# UNITED STATES PATENT AND TRADEMARK OFFICE

APPLICATION NO.	FILING DATE	FIRST NAMED INVENTOR	ATTORNEY DOCKET NO.	CONFIRMATION NO.
10/670,168	09/25/2003	Gil M. Vardi	S63.2H-12012-US01	2222
23552	7590	09/18/2007		
MERCHANT & GOULD PC P.O. BOX 2903 MINNEAPOLIS, MN 55402-0903			EXAMINER HOUSTON, ELIZABETH	
			ART UNIT 3731	PAPER NUMBER
			MAIL DATE 09/18/2007	DELIVERY MODE PAPER

# Office Action Summary

**DETAILED ACTION**

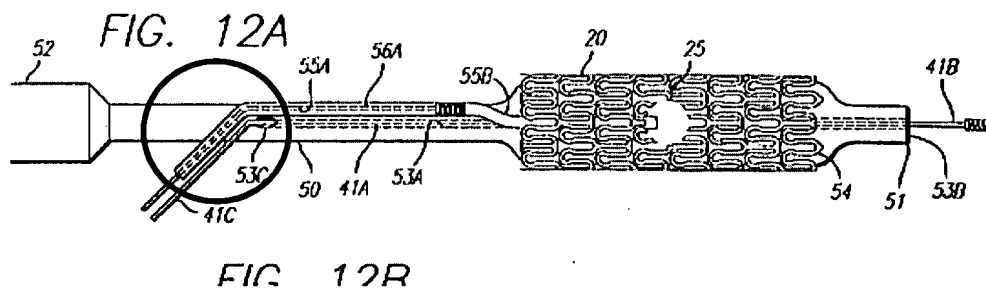
7. Claims 1-4, 13-19 and 21-22 are rejected under 35 U.S.C. 102(b) as anticipated by or, in the alternative, under 35 U.S.C. 103(a) as obvious over Wilson (EP 0 897 700).
8. Wilson discloses catheter system for positioning a stent at a vessel bifurcation substantially as claimed (see entire document). Specifically, Wilson discloses a catheter

(Fig 12a-c) comprising a channel (53a) having a main guidewire lumen extending from a distal end (51) to a main exit port (53c) located at a first distance. There is a branch guidewire enclosure (55a) extending proximally from a side opening (25) of a stent (20) to a branch exit port (see for example 56c) located at a second distance. The branch guidewire enclosure is coupled to the channel adjacent (or near, close to) the branch exit port. The first and second distances of the exit ports are less than a distance from the proximal end to the distal end of the catheter and greater than a distance from the distal end of the catheter to the proximal end of the stent. The device has a balloon (54) and an inflation portion for inflating the balloon. The catheter comprises a bond portion (indicated by circle - see below) that connects the main exit port, the branch exit port and a proximal tube.

9. Regarding the limitation "said first distance and said second distance being *substantially* equal"; the use of language such as "substantially" is terminology of a relative degree and merely requires that the prior art show the distances being close to equal.

10. Alternatively, should applicant disagree with examiner's interpretation of the terminology "substantially", examiner asserts that would be obvious to one having ordinary skill in the art at the time of the invention to vary the size of the branch guide

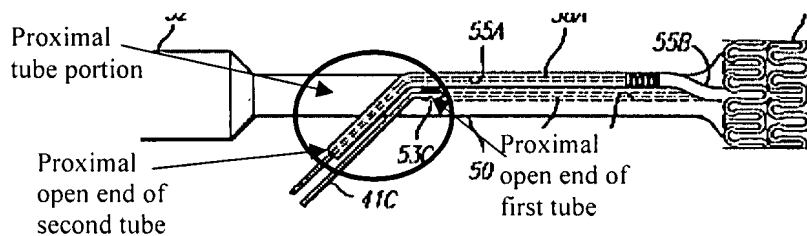
11. Regarding claim 13, Wilson discloses a catheter with a proximal tube *portion* and a distal *portion* comprising a first tube (53A) with a proximal open end (53C) and a second tube (55A) with a proximal open end (for example 56C). There is a bond *portion* that connects that proximal tube *portion* with the distal *portion*. The bond portion has a three-way bond that couples the proximal tube portion to the proximal open end of the first tube and the proximal open end of the second tube.

12. The first/main guidewire lumen/tube is attached to the branch/second lumen/tube external of the bond portion. The bond portion is located at a predetermined distance proximally from a proximal portion of the stent. The proximal tube portion connects to the bond at a distance from where the distal portion connects to the bond. The first and second guide wires exit at the bond portion.
